To: INCITS Technical Committee T10  
 From: Kevin Butt  
 Date: May 1, 2007 3:15 pm  
 Document: T10/06-462r6 — SSC-3: Keyless Copy

### 4.2.20.4 Keyless copy of encrypted data

**FIGURE 1. Flowchart describing a keyless copy operation**

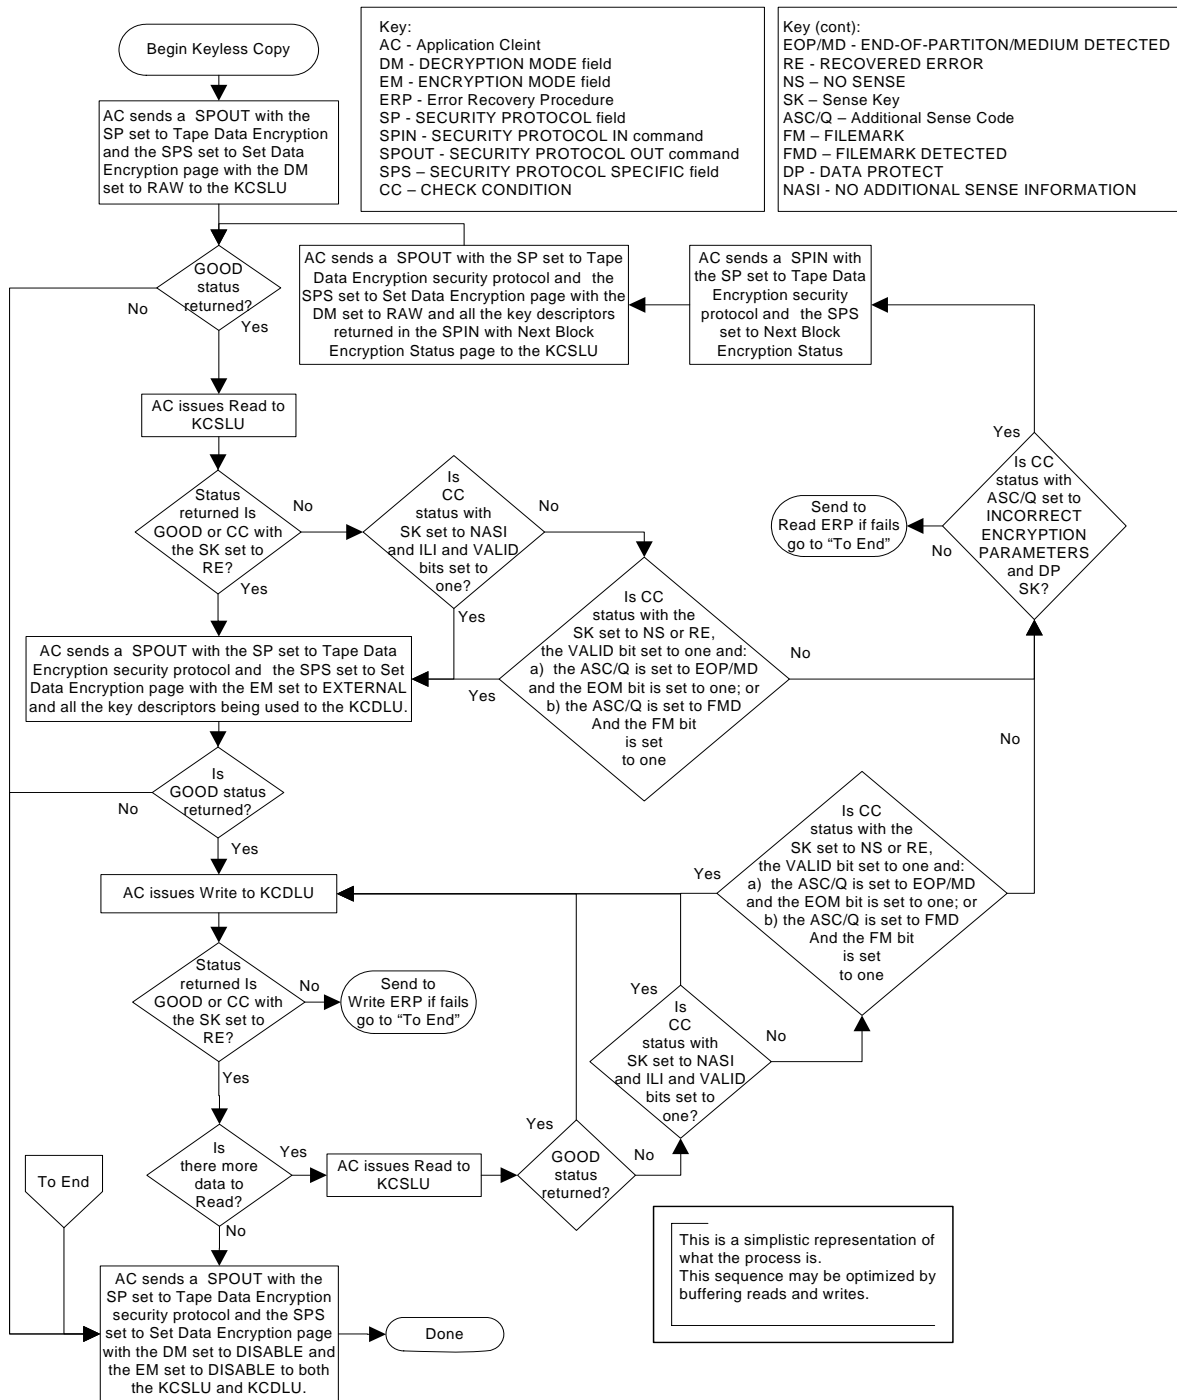
8. 06-462r5 Modified the figure to describe an example of how an application client might implement a keyless copy, listed where to return to the flowchart for ILI and FM Check Conditions.

To accomplish a keyless copy operation an application client sets the KCSLU decryption mode to RAW and the KCDLU encryption mode to EXTERNAL. The application client then reads one or more logical objects from the KCSLU and writes those logical objects to the KCDLU. During this process if the KCSLU detects a mismatch between the key-associated data in the data encryption parameters and the key-associated data on the medium during a read operation, the KCSLU returns a CHECK CONDITION status to the application client to notify it that some action is required. An example of this is shown in the informative flowchart in Figure 1 on page 4.
